Inquiry 156 Woodford St.

Subject: Proposal to install gas-fired oven  
on 1st story of building at 156 Woodford Street

Subject: Installation of oven at 14 York and  
Street and alterations in the structure of the  
building to make way for the oven - H. to support  
the oven.

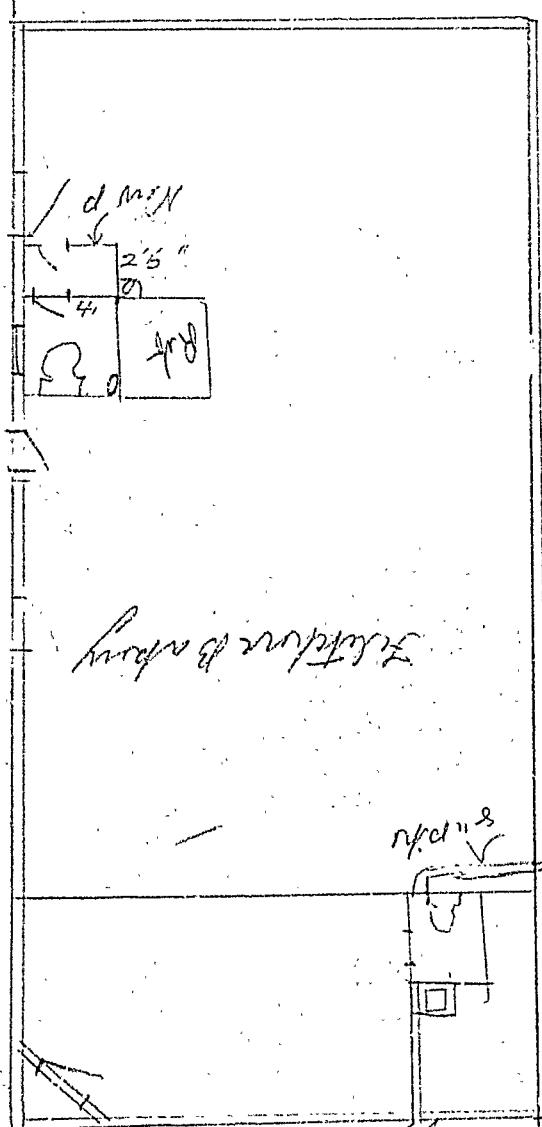
1. From the figures that have been furnished me by Mr. Fletcher as to the clear headroom and the information from the oven manufacturer's catalogue left here, it seems apparent that there will be plenty of clearance (no less than 18 inches) from the top of the shell of the oven and the combustible material of the building above. The closest place will be the wooden beam, the supports of which have to be adjusted in order to make room for the oven. There is a question in my mind if the operating machinery of the oven which sits on top of it will clear the ceiling if all of the figures which have been given are correct. This is something for you and the installer to straighten out, of course, but if any further adjustment of the framing of the second floor is necessitated by this situation, we must have full details of it by way of a plan.

2. The clearance of the vent pipe from the oven to the chimney to the ceiling above it ought to be at least 15 inches.
3. The new pipe columns are not permitted to be second-hand pipe and are required to be anchored top and bottom. The new pipe columns under the built-up beam are apparently intended to be supported in the ceiling on new "H" columns. The best construction regarding that the columns in the first story go end and not in bearing on and be fastened to the "I" beams in the ceiling. If it is intended to rest the columns in the first story upon the existing wooden girders, it must be demonstrated that the reaction of the columns will not overload the roadway of the girder. Of course if the upper column goes down through and rests upon the lower one, the present girder must be cut and both ends at the break will have to get a good bearing upon the lower column and be anchored to it. If a number and the construction of the oven, there is a possibility that half of the load, approximately 12,000 pounds, might be concentrated upon the plate and slab under the center of the oven and would have to be supported wholly upon the new pipe column to be provided in the ceiling. It seems necessary to provide some type of slab or plate reinforcement large enough in area to be anchored to the top of the column so that this very substantial load would have a reasonable bearing area.

4. Since the post is to be removed from beneath second floor beam toward the rear from the oven and the present beam reinforced, the post supporting this reinforced beam will naturally have more load upon it than before and apparently is now and will be supported upon the lintel over the opening in the existing masonry wall in the ceiling. The strength of this lintel ought to be investigated to make sure it is strong enough; if not, it ought to be reinforced.

5. Both of the reinforced beams under the second floor will have an unusual width of bearing. Some satisfactory method will have to be worked out of transmitting the entire width and area of bearing from the built-up beams so that the new reinforcing beams will get suitable bearings as well as the existing beam.

P.S. I am unable to check satisfactorily the strength of the reinforced beam to be provided on a span of about 15 feet where the post is to be removed toward the rear from the oven. I can find nothing on the plan which shows the size of the present beam. Mr. Sears, the builder, says that it is 6x8 but I do not know whether Douglas fir or spruce or what. Even figuring the existing 6x8 and the 2-6x12's to be added as Douglas fir the beam does not seem to figure out. I would like to have Wadsworth & Boston straighten this matter out before this post is removed and before the reinforcing beams are sent out there; also indicate how this beam is to get a good bearing on the wooden post since the 6x8 is shallower than the 6x12. It would be well at the same time to show that this post will adequately support over the opening below.

Accompanying this is a revised drawing of the basement of the Fletchers Bakery at 156 Woodfords Street in which I have incorporated the additional column supports suggested in my recent telephone conversation with you.

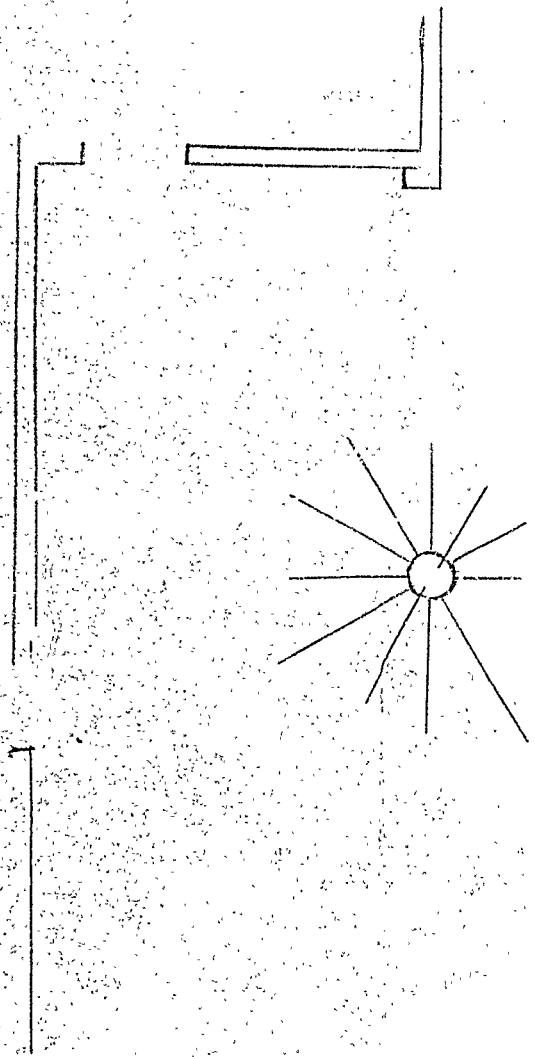
I believe this gives you the information which is required for the basement and the drawing which we made for the first floor would stand unless the girders were changed. Any such change would have to meet with your approval.

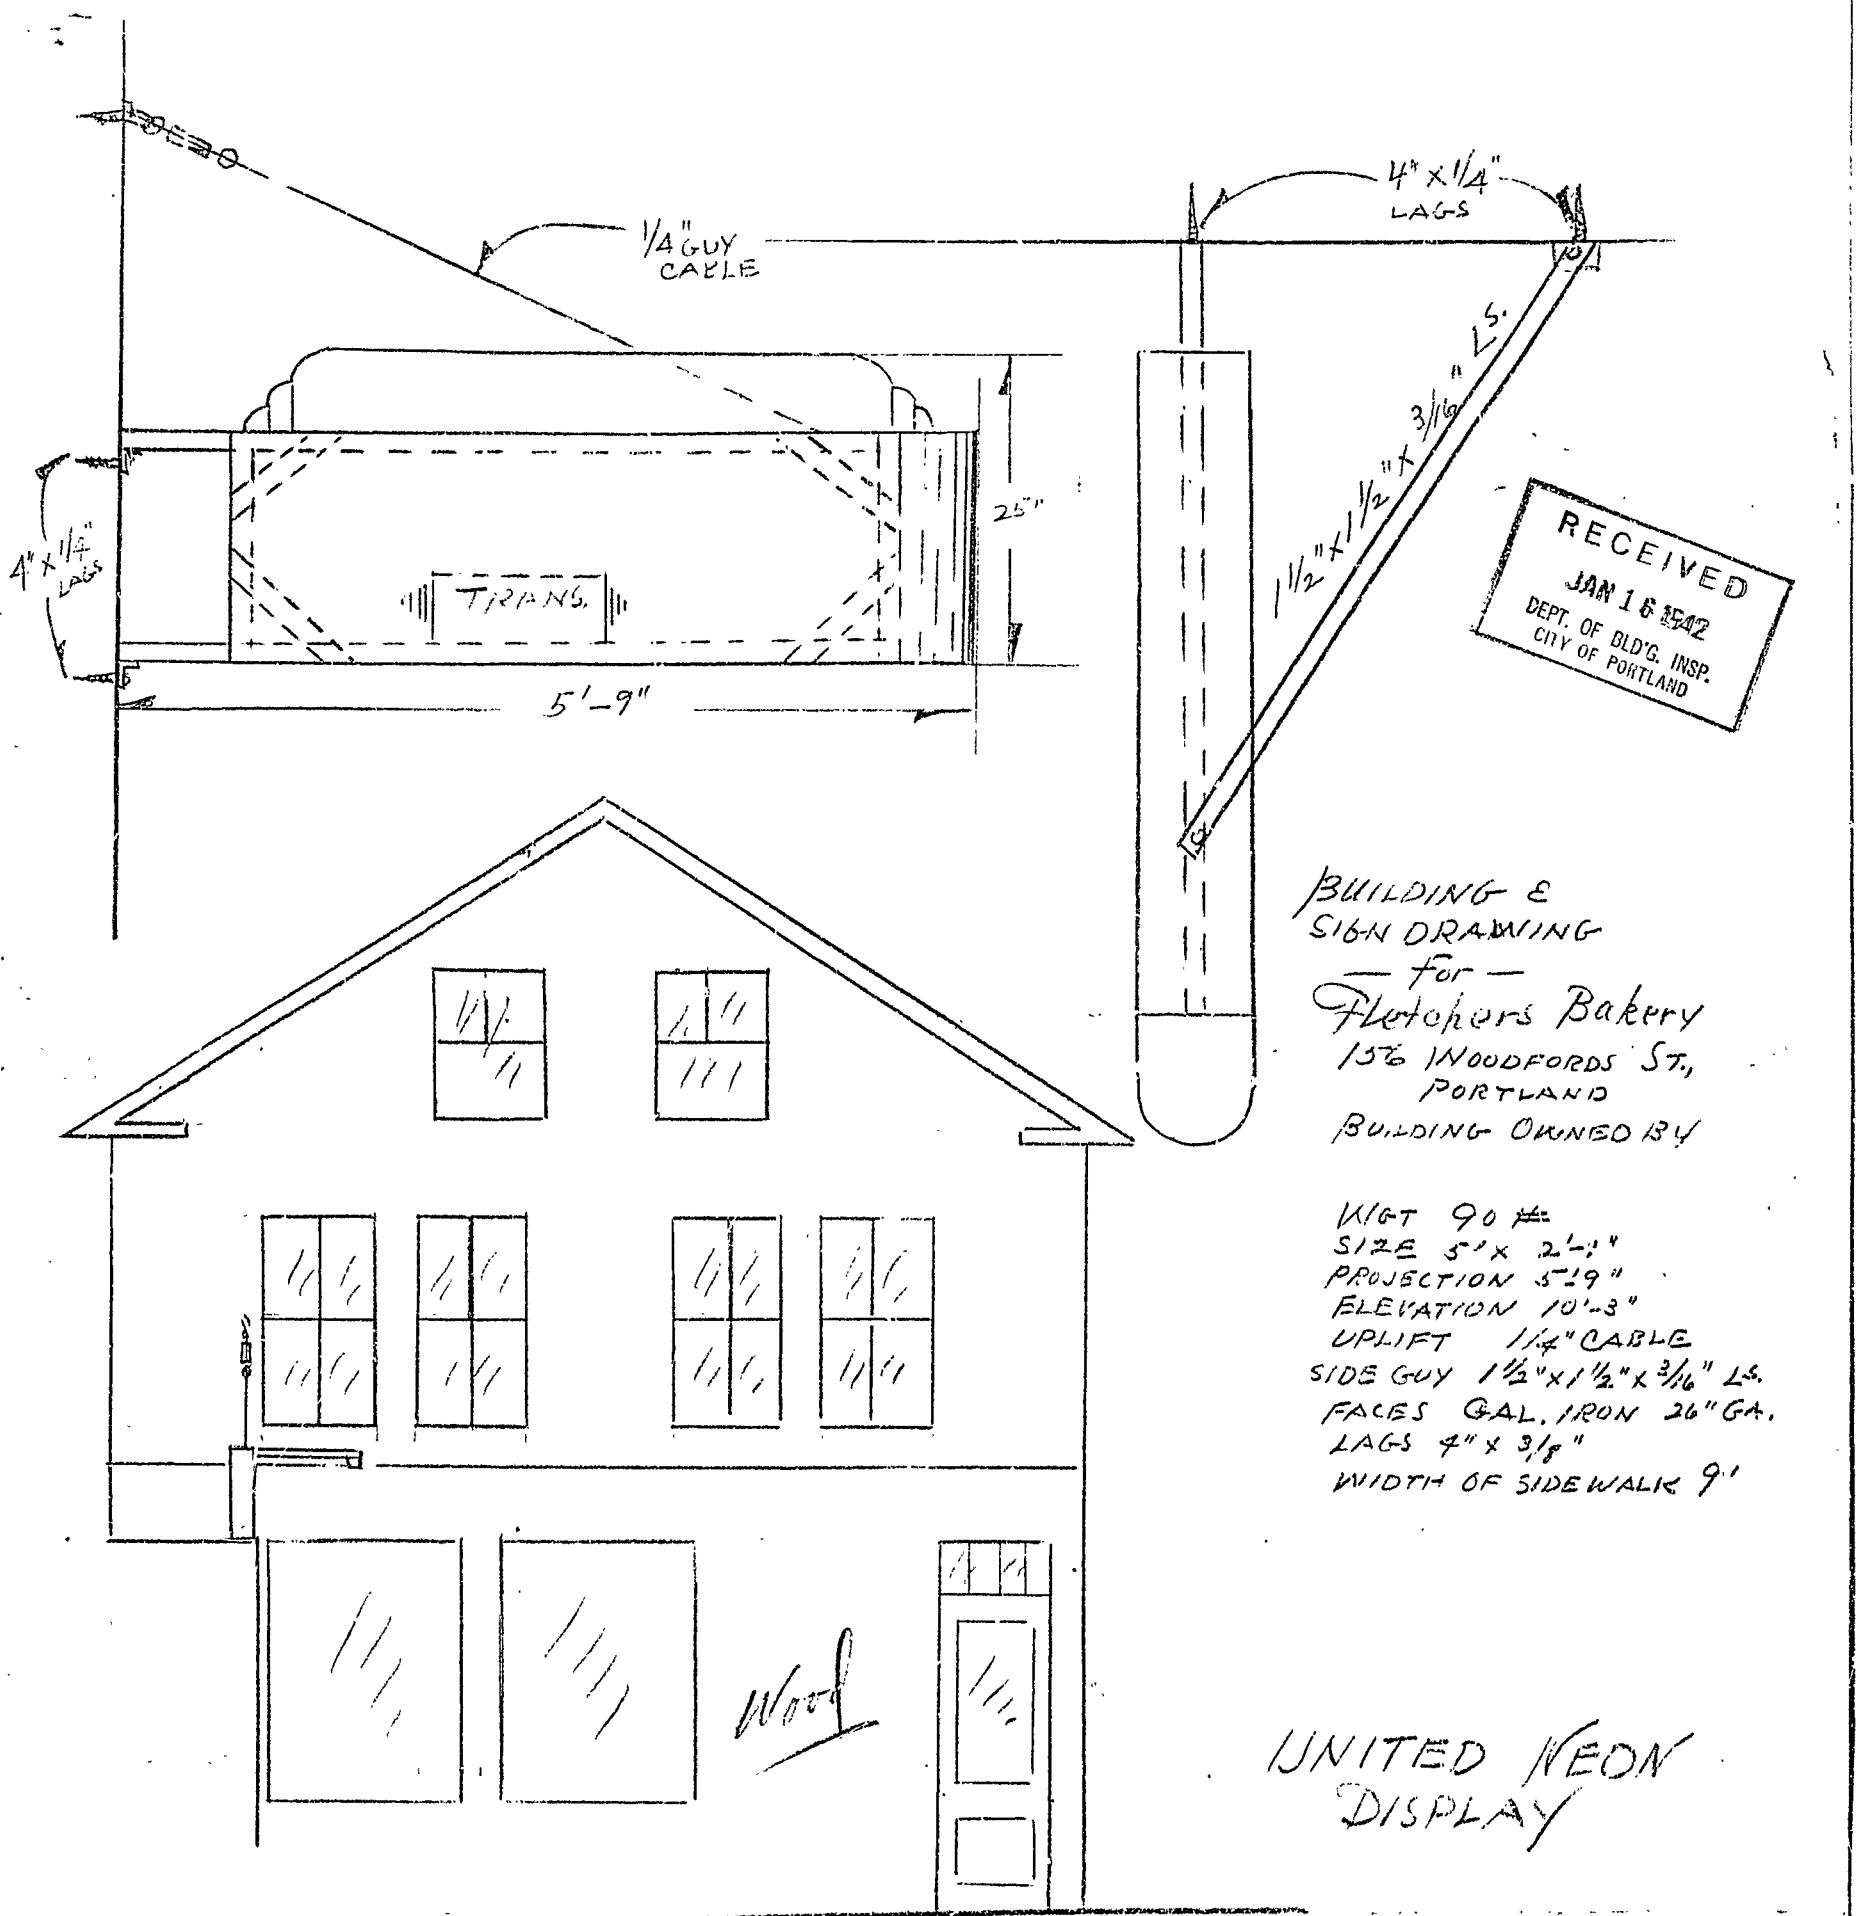
To reinforce first and second floors as per plan to provide for installation of new bake oven
